Jefferson City
Planning & Zoning Commission
Special Meeting

Case No. P16010
Jim Lage
1050 S. Country Club Drive

Preliminary & Final Subdivision Plat
Turtle Creek Subdivision

Jefferson City Planning & Zoning Commission Meeting
Engineering Division Staff Report
Thursday, August 25, 2016, 12:15pm

PRELIMINARY SUBDIVISION PLAT
TURTLE CREEK SUBDIVISION
 SW 1/4 SEC. 8; NW 1/4 NW 1/4 SEC. 17
 T44N, R12W
 34.55 ACRES ZONED RS-2

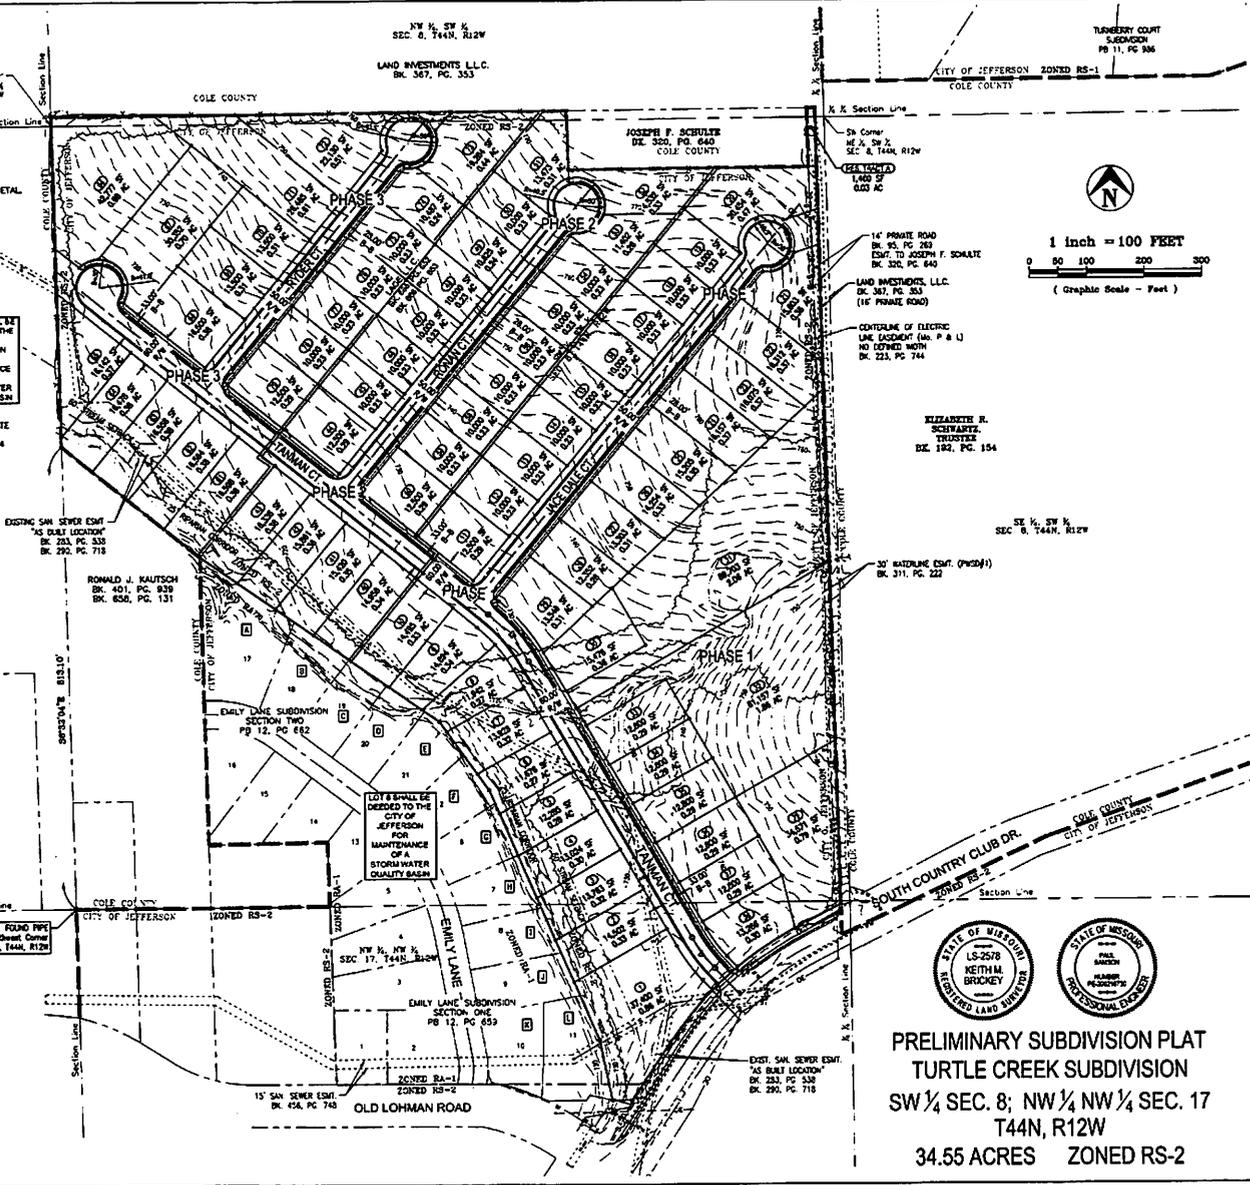
- Storm water detention is not a specific requirement of this project, however storm water quality treatment is required.
- Provisions to address Storm Water Quality are shown proposed as two (2) water quality basins on proposed Lot 8 and proposed Lot 65 of the subdivision. These basins are designed to capture and hold the first 1.37 inches of rain from the subdivision and drop sediment and pollutants from the drainage prior to it entering the creek area. The lots would be transferred to the City for maintenance once infrastructure is completed. **The final design of the basin on Lot 65 should consider some separation of the basin from the existing sewer main (12" diameter clay tile). The basin volume proposed exceeds the required volume, so the footprint could be altered to not be located directly over the sewer main.**

- Drainage swales are shown to collect backyard drainage from homes between the cul-de-sacs. **These swales will need to be designated as private drainageways, but constructed and approved as a part of the acceptance of the subdivision infrastructure. These would be privately maintained by property owners, without encroachment of fences, landscaping etc. Notes will need to be added to the plans/plats as such.**

- An erosion and sediment control plan has been included with infrastructure plans.
- **Please note on the plats/plans that slab homes (without walkout basements) are planned on the lots along the creek.** Homes must be a minimum of four (4) feet above the top of bank of the creek bank. Walkout basements do not look feasible for these lots.

- **A drainage easement will be needed on the southeast corner of proposed lot 9 for the stormwater drainage piping from Jace Dale Court.**

- A five (5) foot sidewalk is being proposed along South Country Club Drive, graded such that a future ten (10) ft. greenway could be added on the northerly side of the street.
- Four (4) ft. wide sidewalk is proposed on one (1) side of all other streets within the subdivision.
- **A sidewalk ramp and sidewalk pad will be needed at each cluster mail box.**

- Facilities proposed within the subdivision are in accordance with City standards.
- **Location of gas service crossings need to be shown on the preliminary plat.**
- **A light pole is needed at the cul-de-sac of Ronan Court.**
